Prairie Island Nuclear Generating Plant Units 1 and 2  
Dockets 50-282 and 50-306  
License Nos. DPR-42 and DPR-60

Response to Questions from "Meeting Summary for Regulatory Conference with  
Northern States Power – Minnesota" held on March 17, 2009 (EA-08-349)

### **NORTHERN STATE POWER – MINNESOTA'S (NSPM) RESPONSE TO QUESTIONS ARISING OUT OF THE 2009 RADIOACTIVE MATERIAL TRANSPORTATION EVENT, REGULATORY CONFERENCE HOSTED BY NRC REGION III.**

Figure 1: Typical Energy Response Relative to Cs-137 (Telepole)

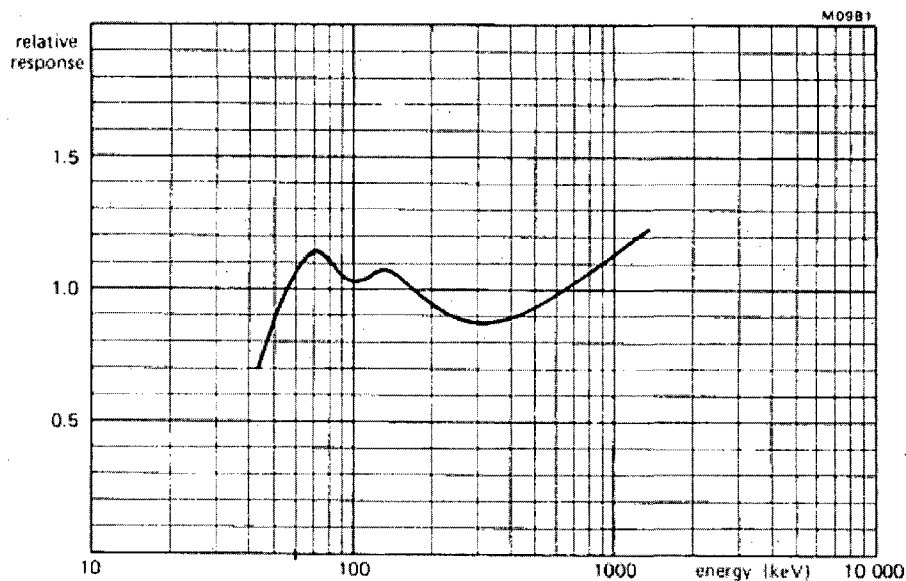
**Question 3: What is the basis for considering the energy compensated Telepole (Geiger-Mueller) measurement inaccurate, given that vendor information and test data demonstrate that the instrument is linear in its response to Co-60 energies in the activity range of interest?**

The MG Telepole G-M tube technical manual states that the instrument energy response is  $\pm 20\%$  at 70 keV to 1.1 MeV relative to Cs-137. In follow up correspondence with Radiological Engineers at Merlin Gerin Instruments, it was confirmed that the low-range G-M tube is the active detector for readings below 2500 mR/h due to a modification in place for a major portion of Telepoles deployed in the industry, including those in use at PINGP. Testing of the low-range tube at independent laboratories resulted in an over response to Co-60 photon energies of 26%. A proprietary vendor document contains detailed data demonstrating the over-response. This information is available for review at PINGP. These data are similarly represented by the energy response curve supplied by Merlin Gerin (see Figure 1) for the low-range G-M tube in independent testing.

Based on the reported energy response of the RO-2 and Telepole instruments, the RO-2 will respond very near a one-to-one ratio (0.99 window closed) at Co-60 photon energies when calibrated to Cs-137, while the Telepole will significantly over-respond (+26%) at those same energies. Based on this information, NSPM concludes that the Telepole exhibits a notably non-linear response as it appreciably over-responds to the Co-60 photon field, thereby providing a less accurate measurement of the radiation field when compared to the RO-2 ion chamber's uniform response.
